***Lot 2 DP 748682
132-138 Killeaton Street, St Ives***

***MP10_0057 MOD 4 – Modification to Amend
RLs and Rooftop Areas***

Director-General's
Environmental Assessment Report
Section 75W of the
Environmental Planning and Assessment Act 1979

Figure 11 – Eastern elevation plan demonstrating the proposed location of pergolas to Block F which are visible from this perspective.

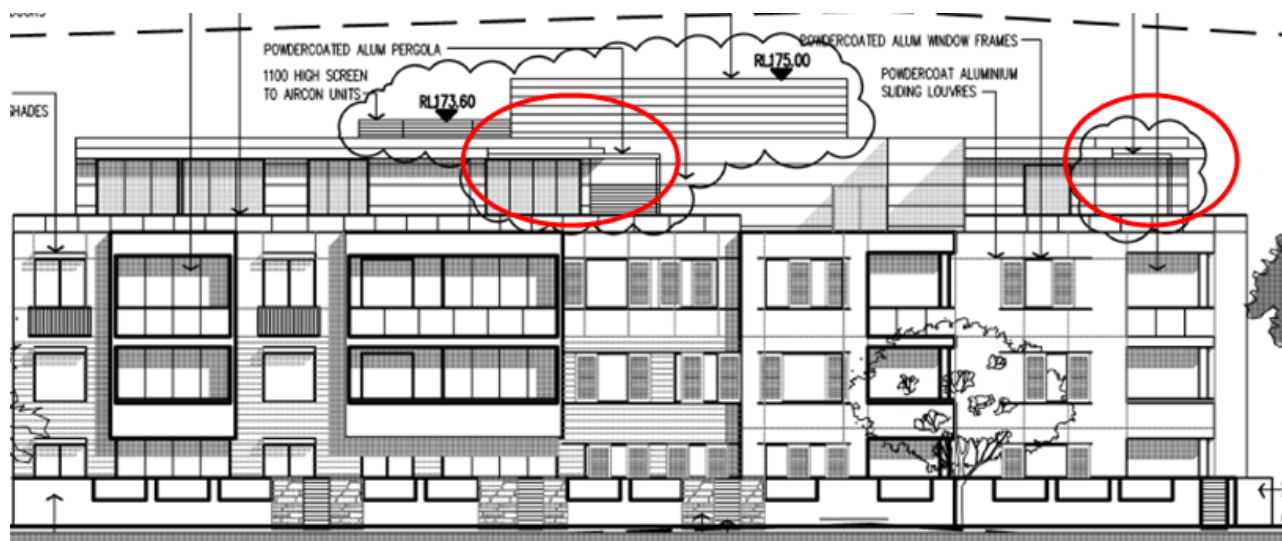
The proposed addition of pergolas for eleven top floor apartments reflects the intent of the Residential Flat Design Code as it enhances the residential amenity for future occupants by providing shading and glare control for these private open space areas. The pergolas are considered to be minor light-weight additions that are consistent with the approved ceiling heights, will match the approved colours and materials of the development, and are in keeping with the

scale of the overall development as demonstrated in **Figure 11** below. Given these points, the department considers that the pergolas will maintain the approved appearance of the development and are supported.
